# LANDMARK COMMISSION REPORT

149 E. WATER ST.

THE GRANARY BUILDING

Reference Number: PLC 23-0001

## 2. Storefront Alteration

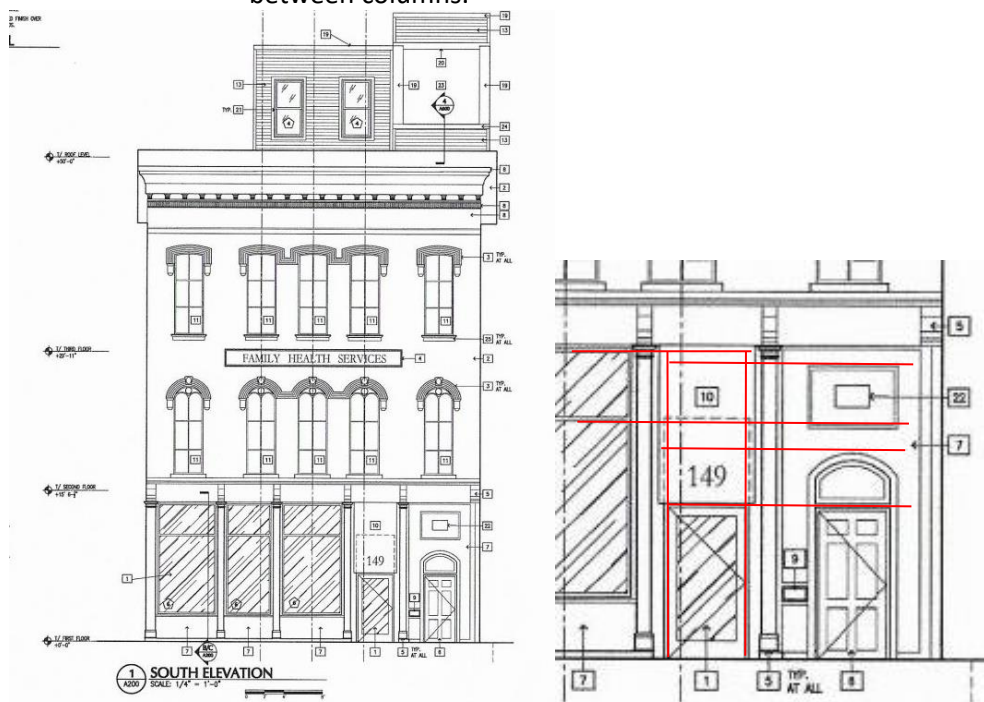
- i. The existing aluminum storefront windows are being replaced with new aluminum storefront in a dark bronze finish. The applicant has stated the framing is not historic, but for the columns. The historic columns will remain intact.

- i. New entry doors. The existing door will remain and will serve as an emergency exit for the stairwell. The new door will be located to the left of the existing door, where there is currently a window. Staff expressed the new door design would benefit from being aligned with the existing door design in rhythm and number of features: specifically, a rounded transom above the door and signage placement in similar size and alignment. The applicant stated they would provide a concept for the tenant to review before presenting it to the commission. At the least, the proposed signage should align with the new doorway and not span the entirety of the space between columns.

Recommended alignment of new door and signage design with existing features

Like most downtown buildings, the storefronts have been renovated multiple times over the life of the buildings. The window replacement and addition of a doorway are appropriate for the storefront. Keeping the columns is preferred, and the proposed plans do so. For the new additions to balance with existing features, staff recommends altering the proposed door addition design to align with the existing door, transom, and signage in width and height.

1. All applicable permits are obtained through the Building Department, Engineering Department, and any other applicable agency prior to construction.
2. The new proposed doorway and signage design is aligned with primary features of the existing doorway, including the consideration of adding a transom window above the new door. Signage does not expand above the height of new storefront windows.

## 3. Windows

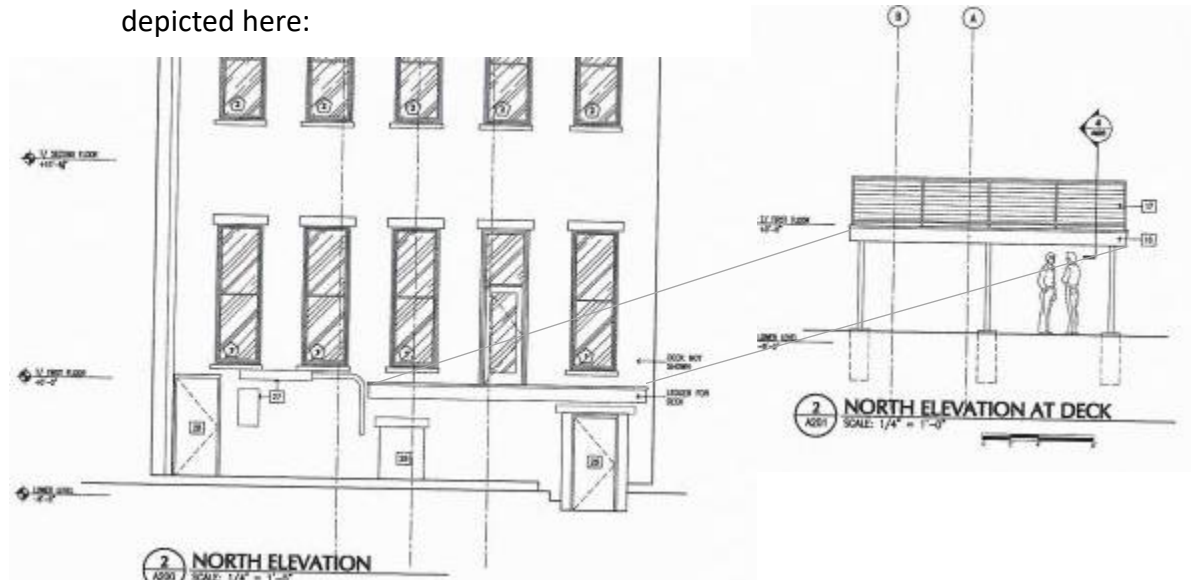
- a. The windows of the 2<sup>nd</sup> and 3<sup>rd</sup> floors facing Water St. are historic and will remain in place, with restoration and painting as necessary.
- b. The applicant seeks to replace all north facing windows. The applicant has stated the windows are non-historic and will be replaced with new traditional, wood, double-hung doors such as Pella Architectural Series – Traditional or a comparable alternate.

All proposed window replacements are appropriate in style and materials such as wood and aluminum. The existing window openings (aside from the storefront) are not being altered in shape or size.

Red outline highlights area of staff concern

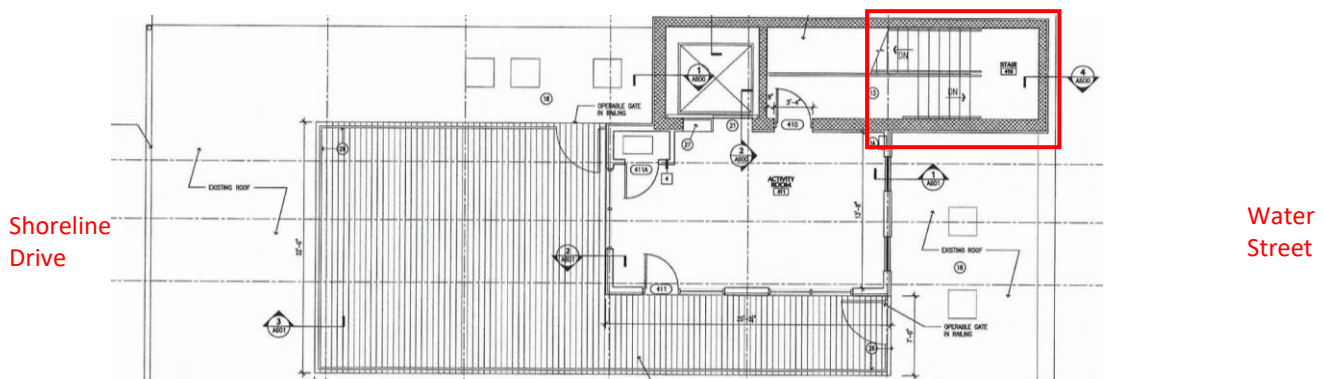
- a. Open patio
  - i. Setback from Water St. façade ~15'
  - ii. Setback from the Shoreline Dr. façade ~15'
- b. Roofed patio section
  - i. Setback from the Water St. façade ~15'
  - ii. 10 feet in height
- c. Stairwell
  - i. Is proposed to be in line with the Water St. façade
  - ii. 15 feet in height

The drawings included depict the following:

#### North Elevation – Internal Staircase

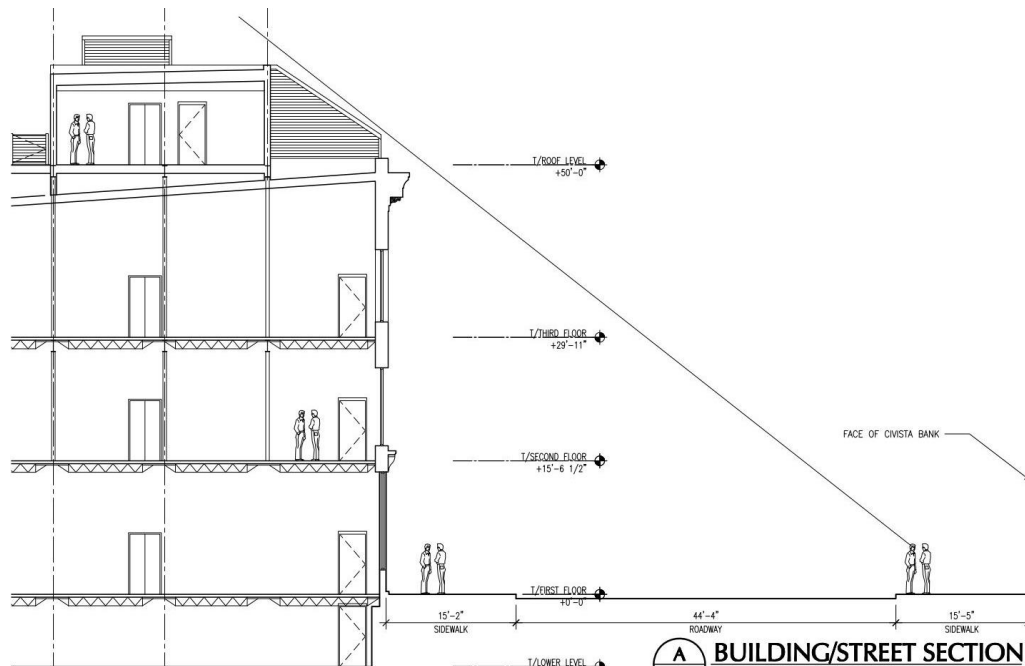
The staircase structure is placed up to the front façade of E. Water St. Due to the shape of the staircase structure- only ~3 ft. of the staircase would be visible from the vantage point of across the street. Therefore that addition is not “substantially visible” and is appropriate according to the national guidelines.

The proposed design and materials of the rooftop addition are otherwise appropriate as proposed.

### Exterior Lighting

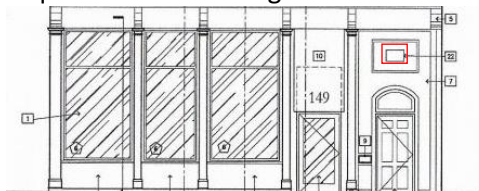
The guidelines encourage to use small lighting features with a simple design with fixture heads not exceeding 12 inches in height and to avoid excessive brightness. More information is requested for staff to give a recommendation.

2 SOUTH ELEVATION COLOR OPTION B  
A210 NO SCALE

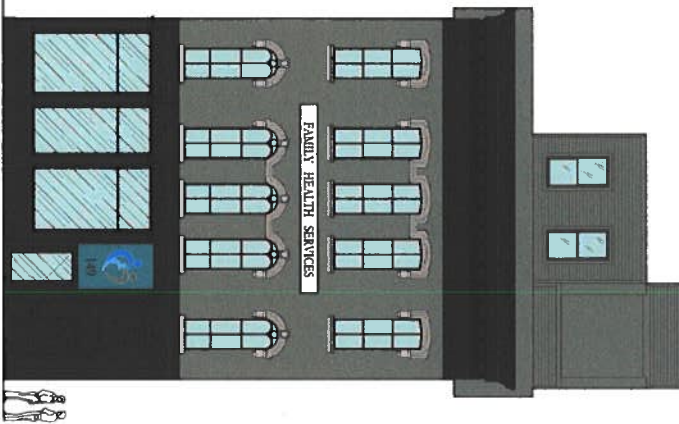
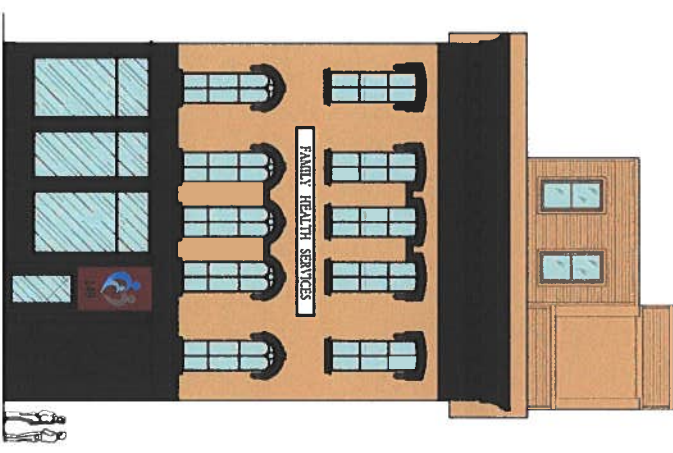
The applicant seeks to make paint color alterations, the documents submitted includes two proposed options. Family Health Services expressed a preference for the blue/green color scheme Option B on the left. Staff discussed with the applicant that using the dark accent color on the decorative moldings with a lighter color for the “braiding” above the windows would provide a contrast similar to the historic photograph while also showcasing an important historic feature and they agreed to modify the concept to include this detail.

Either option A or B meet the Paint Selection guidelines. Option B is preferred by the applicant, and as mentioned they updated the proposed color scheme to include the dark accent trim on the decorative moldings and the lighter color for the “braiding” of the molding’s of the second and third story Water Street façade windows.
